Model: AP-C2.5	Date: 22-Oct-10	No.: RD089002h
----------------	-----------------	----------------

Subject: Firmware Release Note: Engine		Prepared by: Y. Taniguchi	
From: 1st Tech Service Sect., MFP/Printer Tech Service Dept			
Classification:	<input type="checkbox"/> Troubleshooting	<input type="checkbox"/> Part information	<input type="checkbox"/> Action required
	<input type="checkbox"/> Mechanical	<input type="checkbox"/> Electrical	<input type="checkbox"/> Service manual revision
	<input type="checkbox"/> Paper path	<input type="checkbox"/> Transmit/receive	<input type="checkbox"/> Retrofit information
	<input type="checkbox"/> Product Safety	<input checked="" type="checkbox"/> Other (Firmware)	<input checked="" type="checkbox"/> Tier 2

This RTB has been issued to announce the firmware release information for the **Engine**.

(1) NVRAM on the BICU

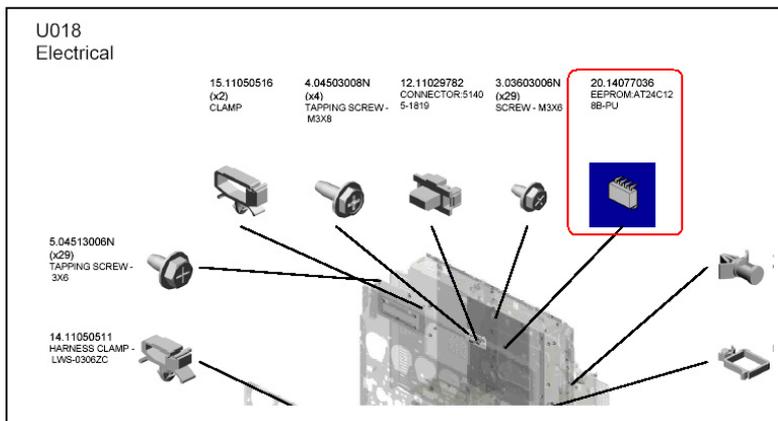
The ***NVRAM*** replacement procedure contained in the Service Manual ***should be*** revised. ***In addition to the existing procedure, whose title is "NVRAM on the BICU", please add the procedure, whose title is "NVRAM on the Controller Board".***

The NVRAM on the BICU is shown above as [B] on the BICU board [A] (See Pg. 295 in the FSM)

Cause

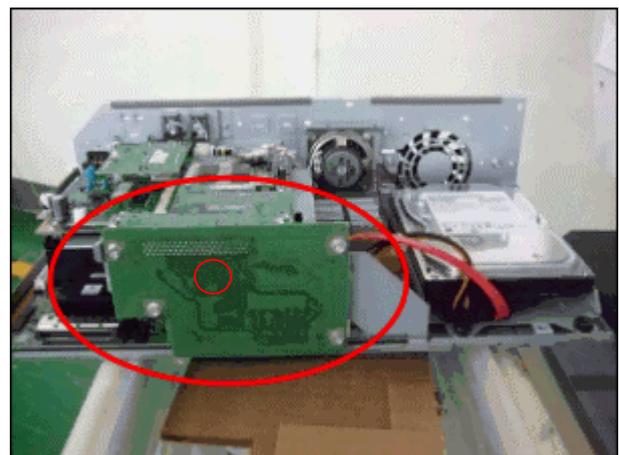
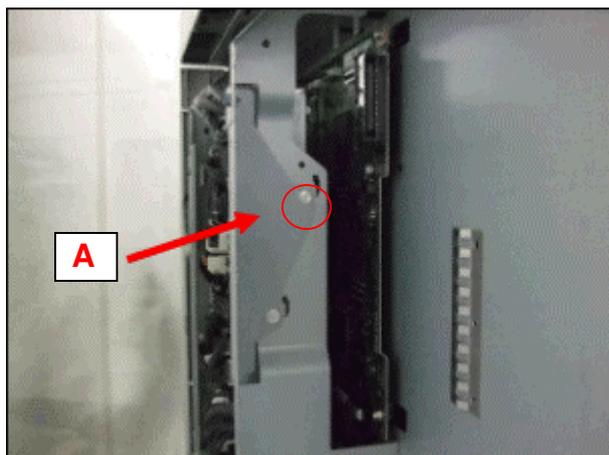
The screw [A] shown below touches the fax I/F board, causing a short circuit.

The screw [A] was shortened and the shape of the two screws [B] fixing the plate in place was changed.

Developer and Toner Bottles

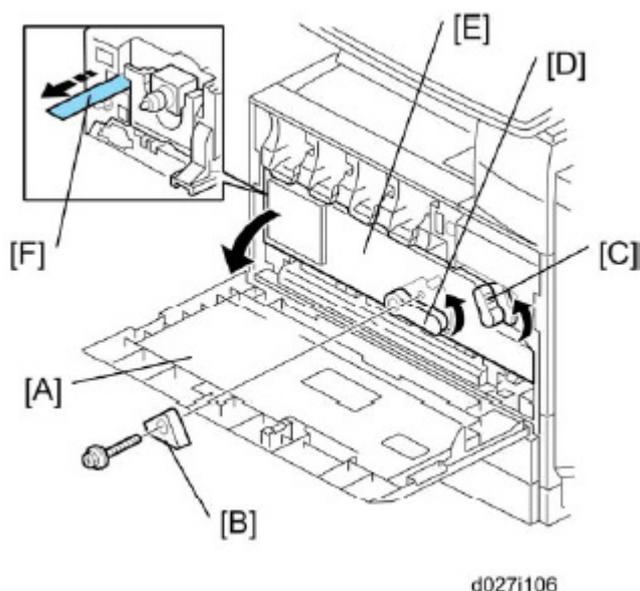
This stopper locks the drum positioning plate lever.
3. Release the image transfer unit lock lever [C], and turn the drum positioning plate lever [D] counterclockwise.
4. Open the drum positioning plate [E].
5. Remove all tapes [F] from ***the four the BK*** development unit ***only***.
NOTE:

Model	Product Code	BICU P/N
AP-C2.5 Normal DF	D088/089-17 D088-19/21 D088/089-27 D088/089-29	D0895105
AP-C2.5 Single Pass DF	D088-69 D89-59/61/69 D088/089-57 D088/089-67	D0895154

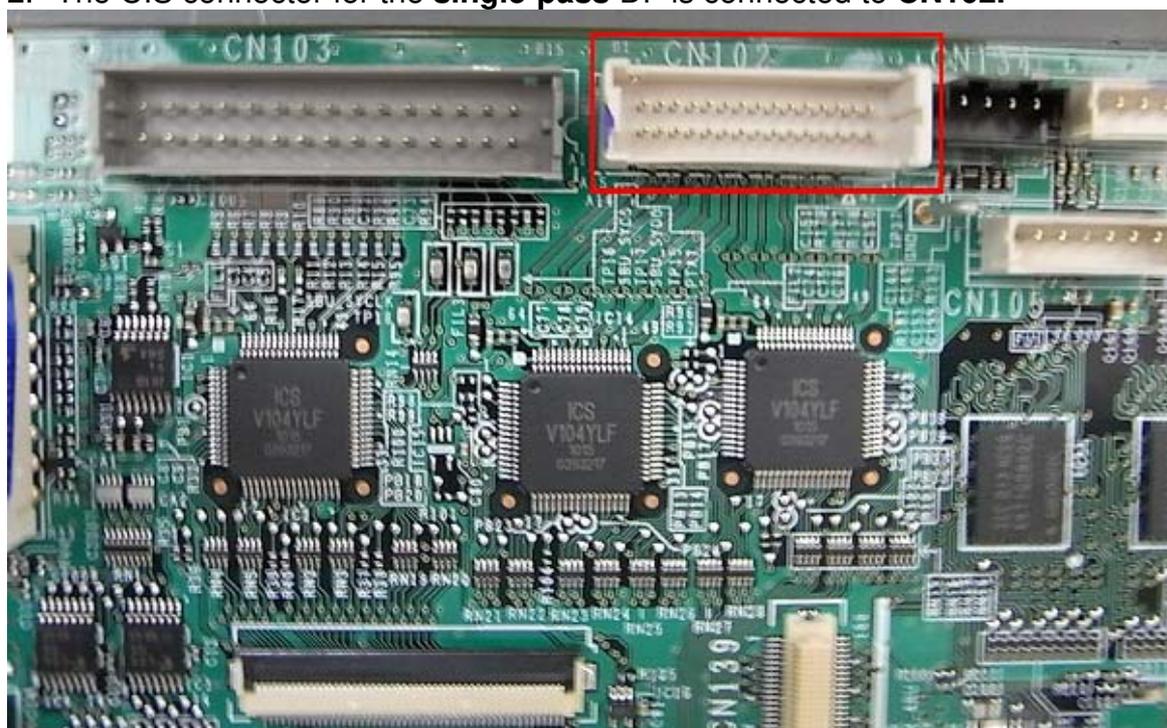
2. The CIS connector for the **single-pass** DF is connected to **CN102**.

Old part number	New part number	Description	Q'ty	Int	Page	Index	Note
-	D0895830	BRACKET:PSU:ASS'Y	1	-	-	-	-

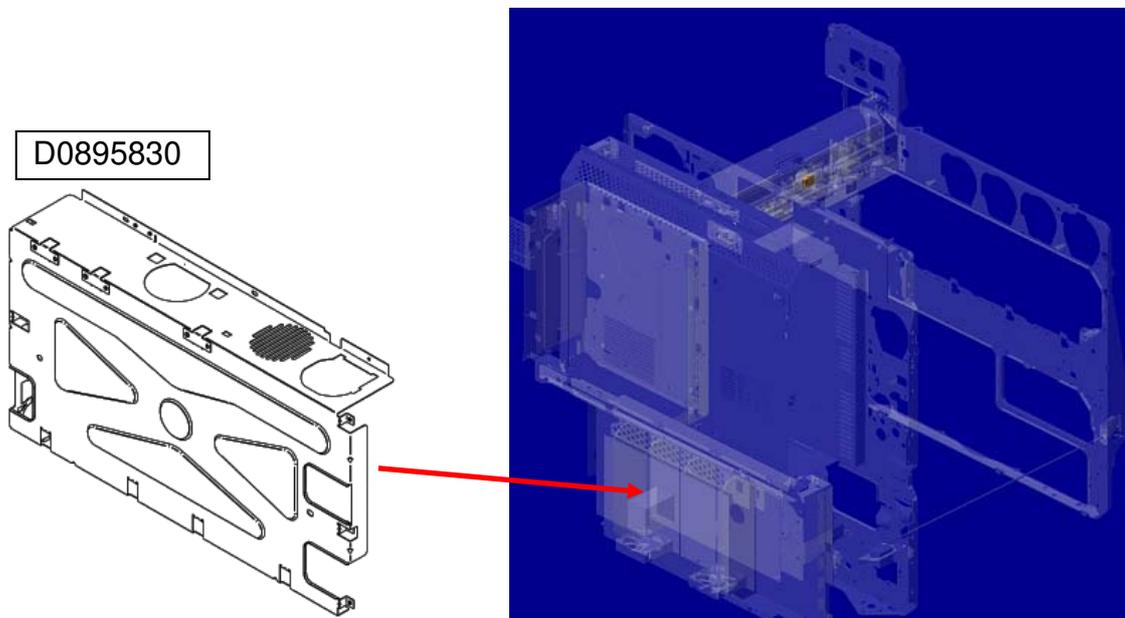
Change: The PSU bracket was added as a service part.

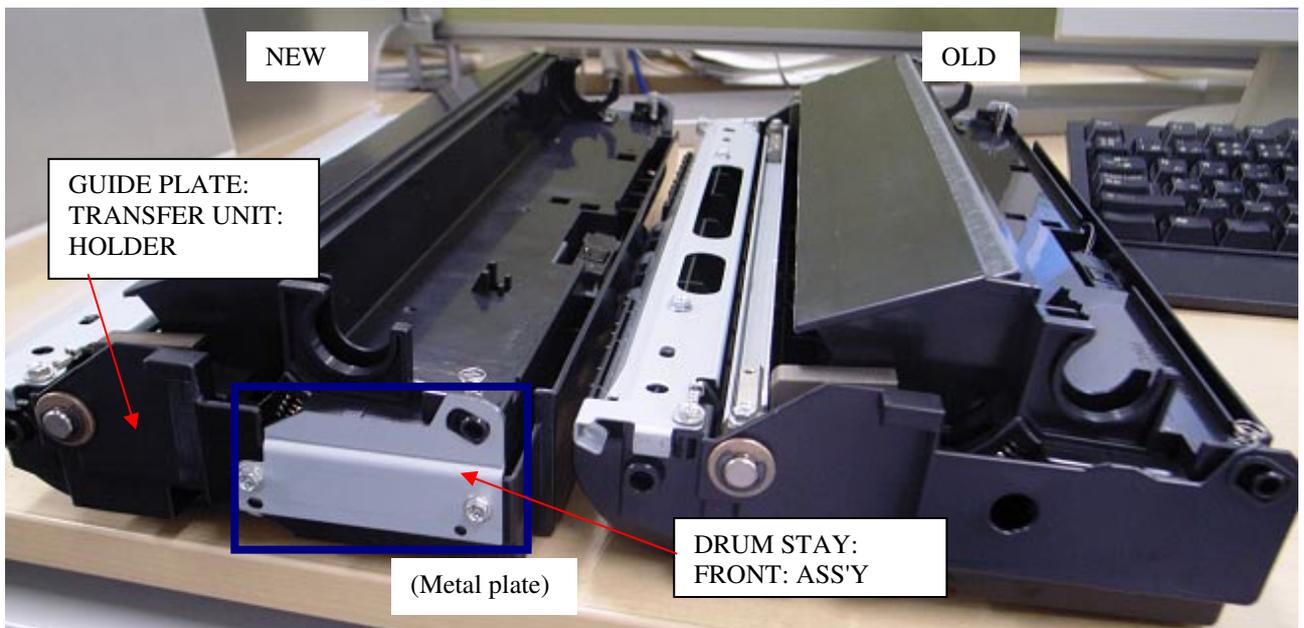
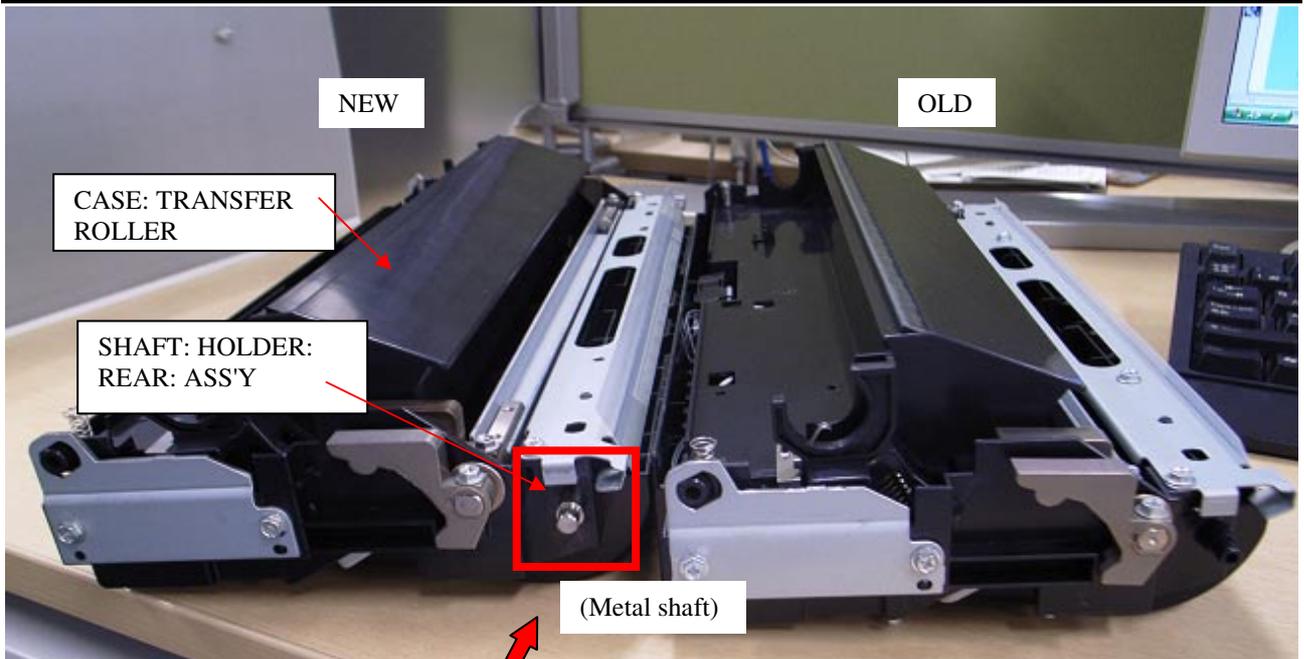
Change: The material of the parts was changed from a resin to a metal.

Reason: To further increase the load-bearing strength of the parts.

Important: Interchangeability is **X/O as a set** (all six parts together).
